Storm Water Detention/Retention Design

Project: Interstate Commerce Center 1 File No.: 06F070.000
County: Butler City/Township: Fairfield/West Chester Twp.

DRAINAGE EXHIBIT

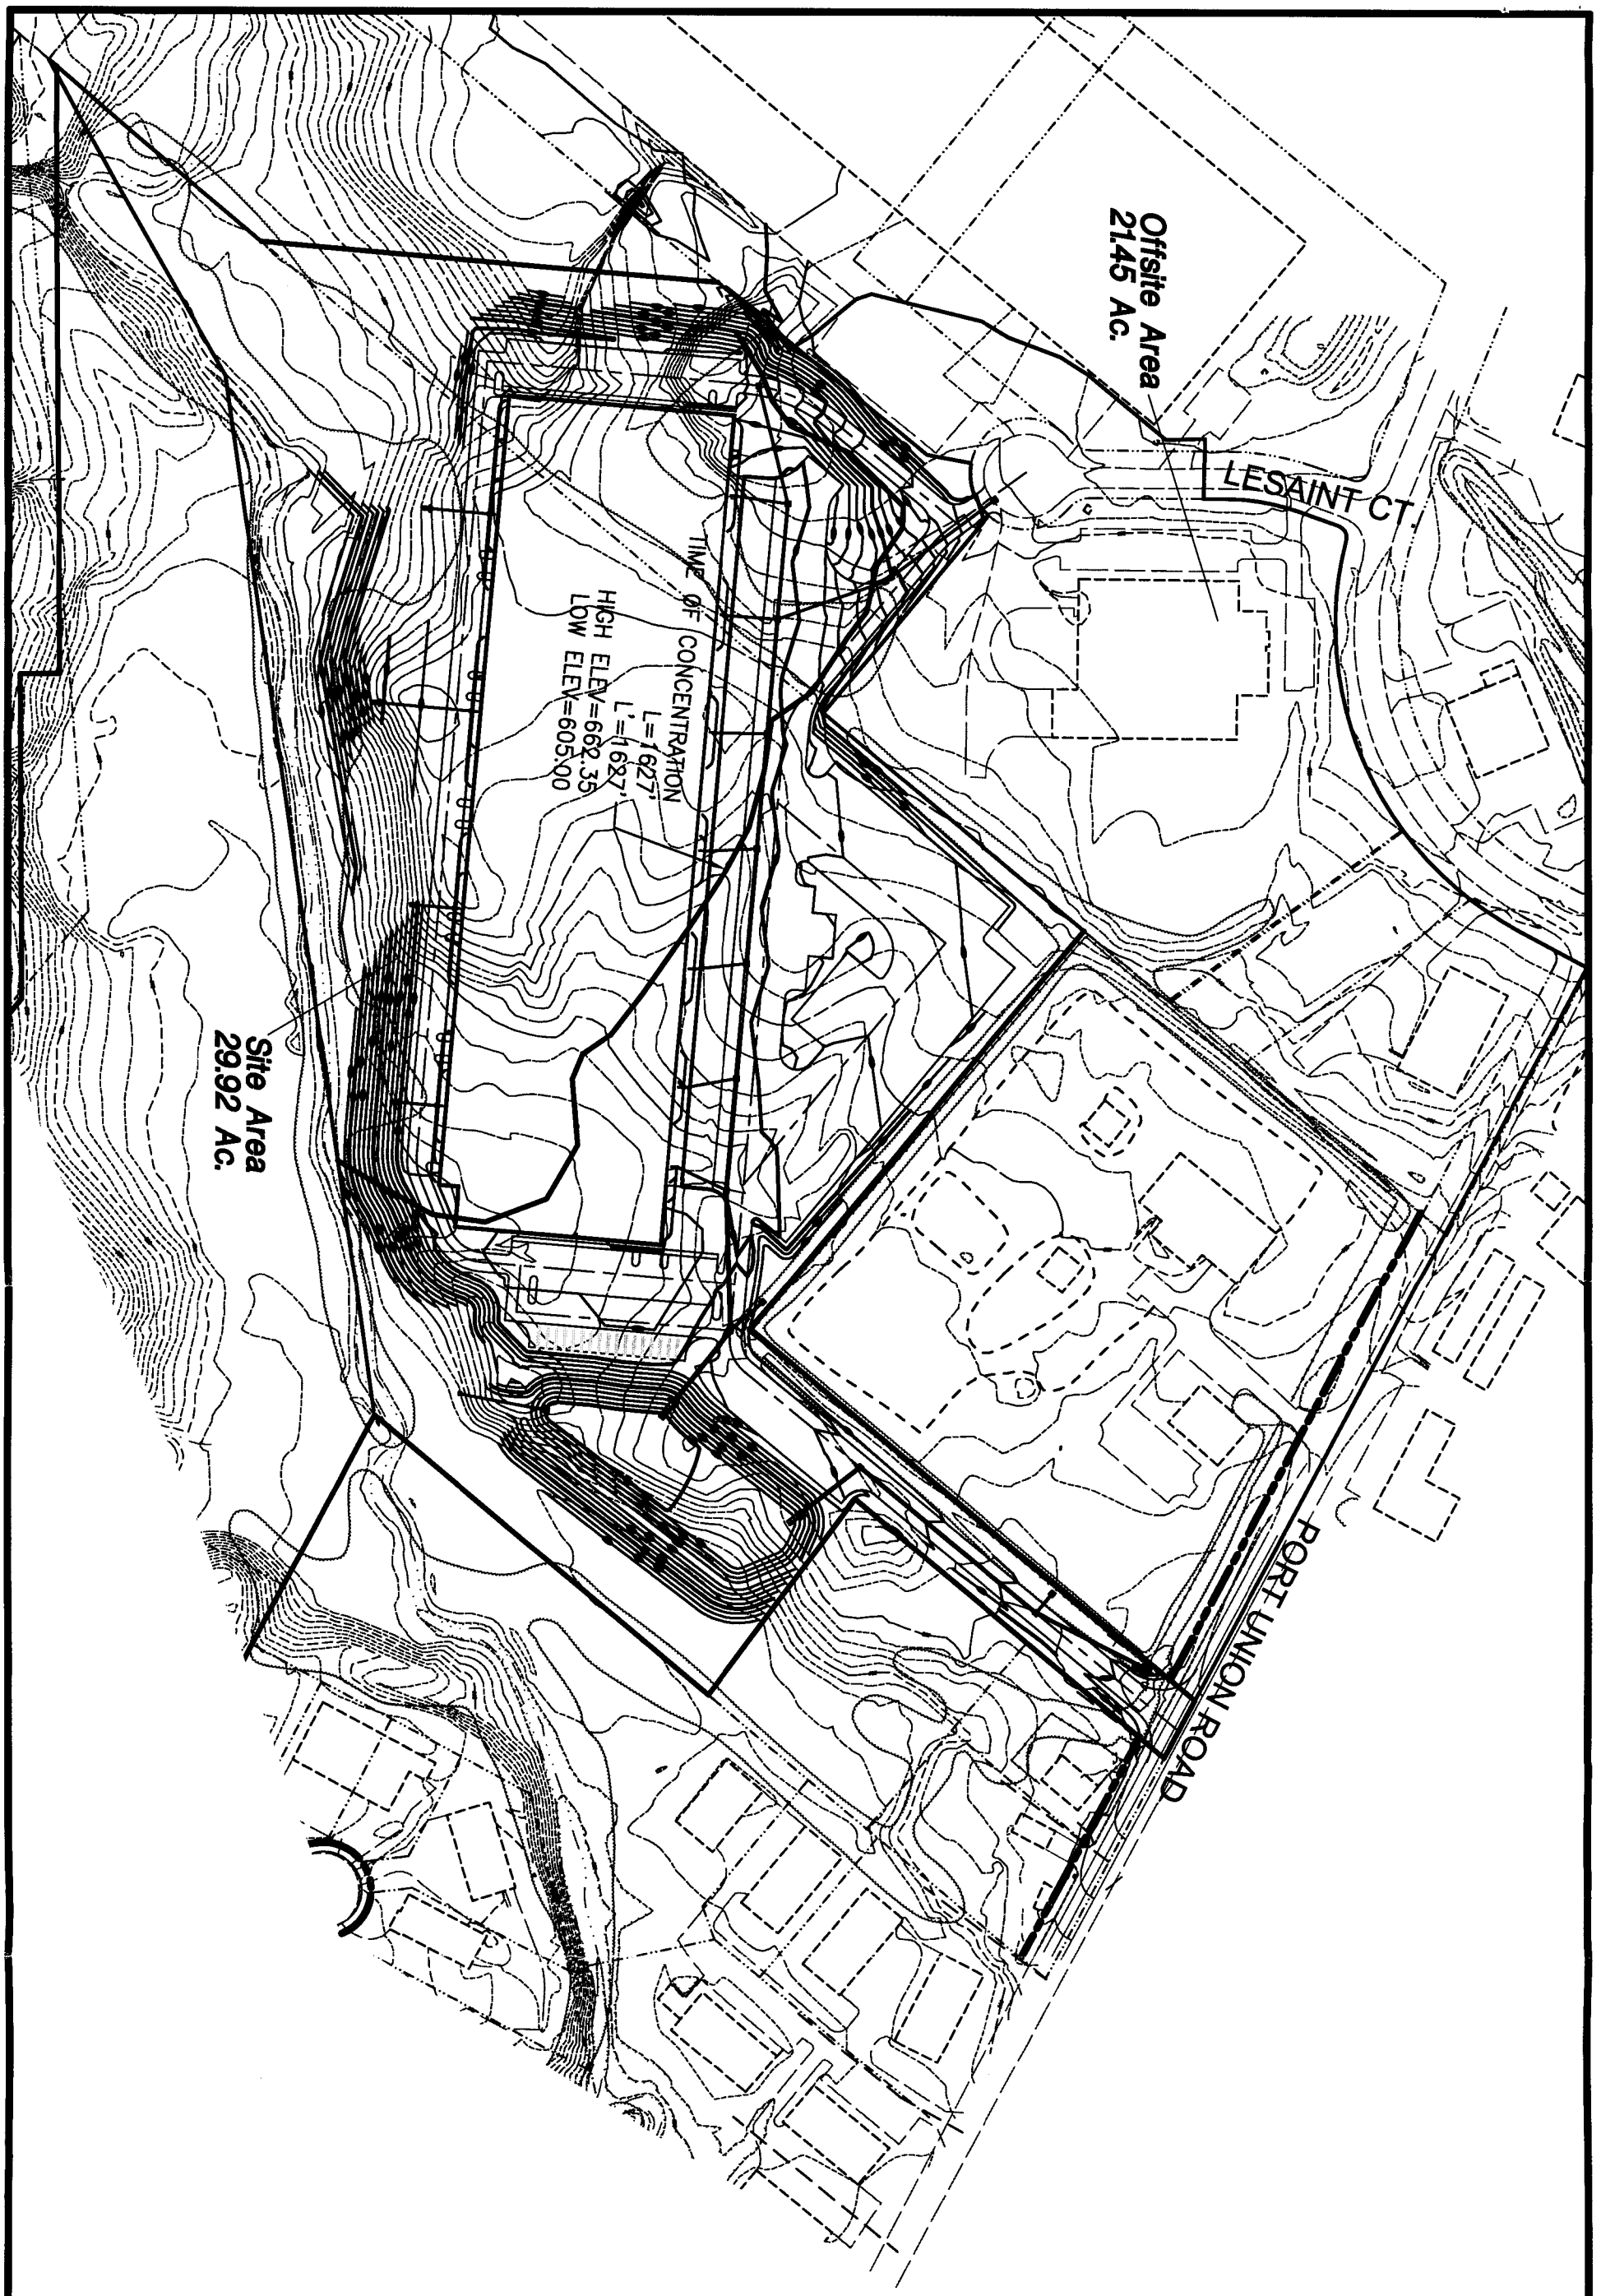
? detention provided in addition to WQv ?
